August 2025
Design Development Updates

Upper Brook Street Masterplan (McLaren / Kadans)

UBS-SRA-XX-XX-RP-A-00101

This document has been produced by Sheppard Robson and proposes minor changes to the approved Sci-Tech scheme located in Upper Brook Street, Manchester.

First Floor
Consented Plan

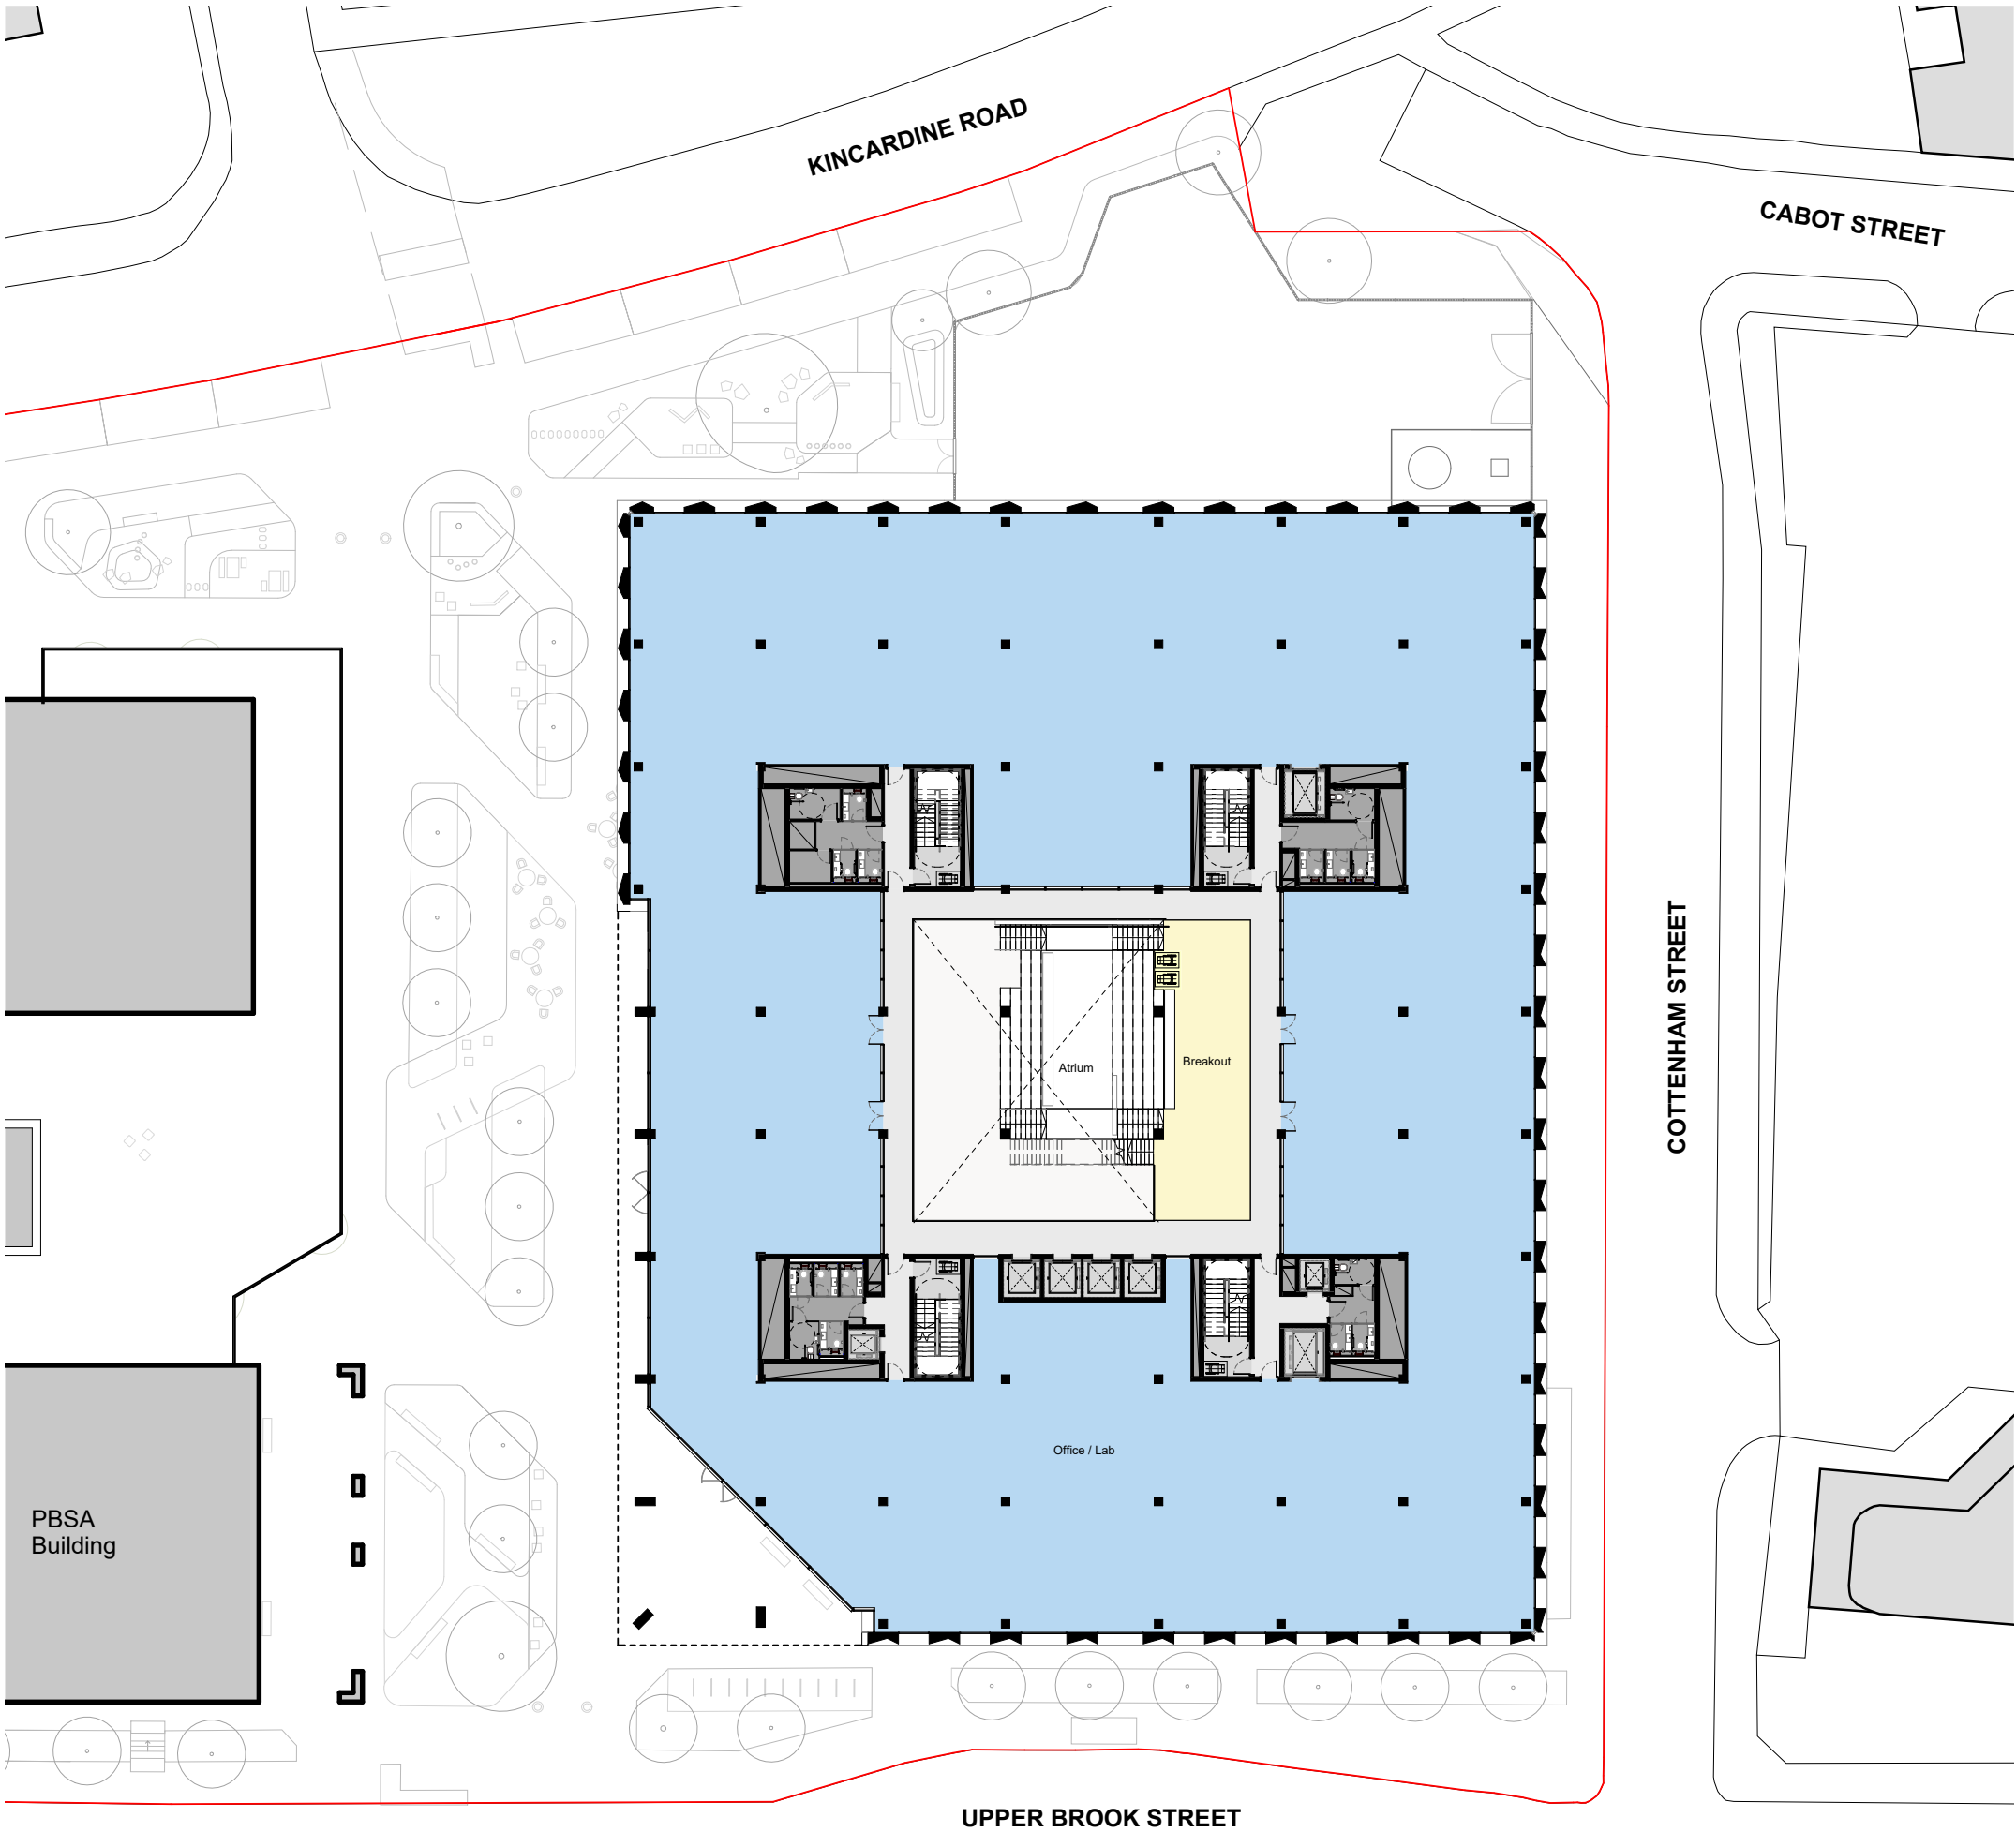
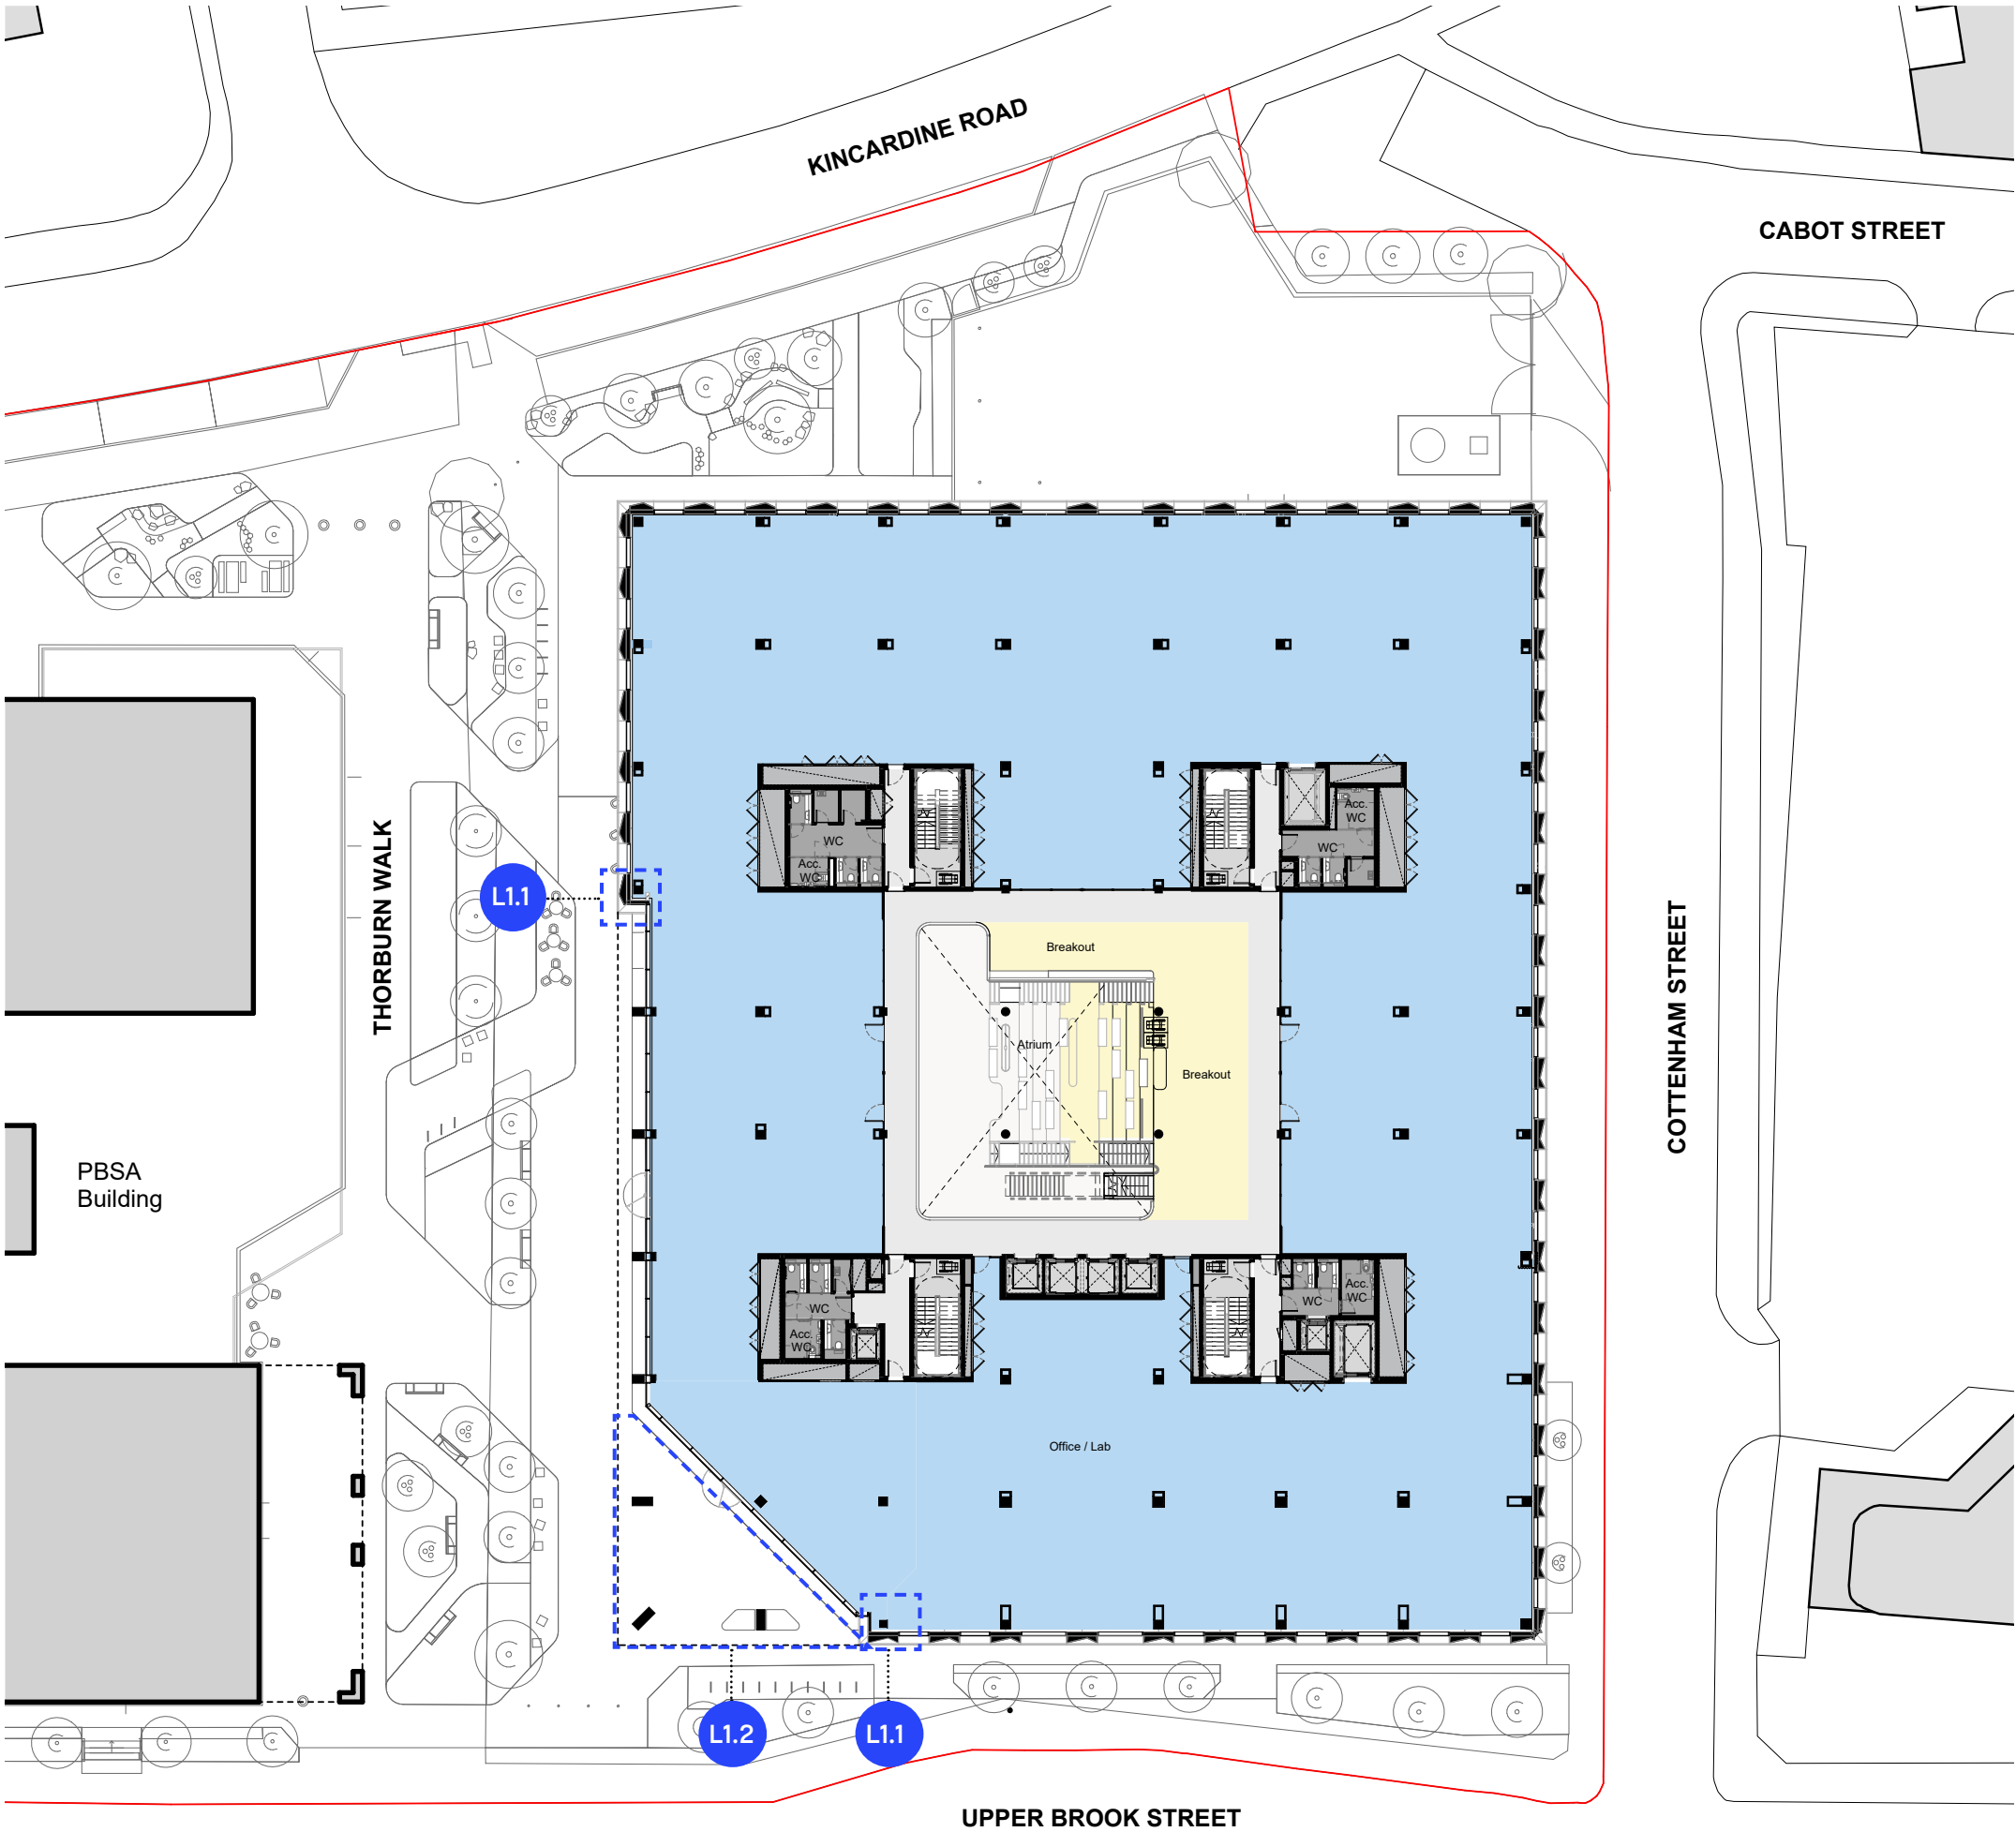
- L1.1 The glazed corner was replaced by a unitised facade panel.
- L1.2 The entrance soffit material was defined as anodised aluminium.

Change Code	Drawings Affected	Description	Design Development Justification
L1.1	- UBS-SRA-ST-00-DR-A-02-501 - UBS-SRA-ZZ-00-DR-A-02-101* - UBS-SRA-ZZ-EW-DR-A-02-311 - UBS SRA ZZ ES DR A 02-307	Glazed corner replaced by unitised facade solid panel	Glazed corner design updated with unitised corner panel for ease of construction and to improve building performance
L1.2	None	Entrance soffit material defined as anodised aluminium	Following a series of design studies, anodised aluminium to match the perimeter cladding of the soffit provided the most solid and inviting entrance.

First Floor
Entrance View

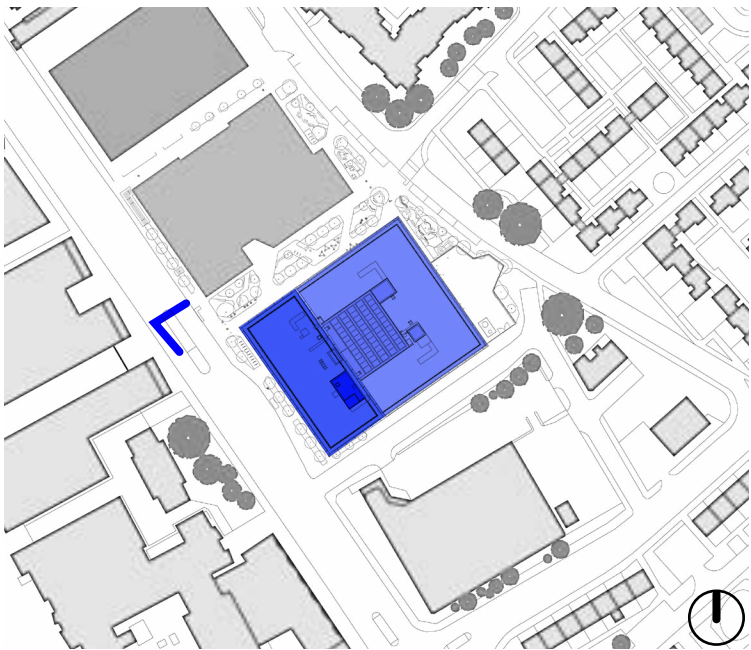
- L1.1 Glazed corner replaced by unitised facade solid panel
- L1.2 Entrance soffit material defined as anodised aluminium
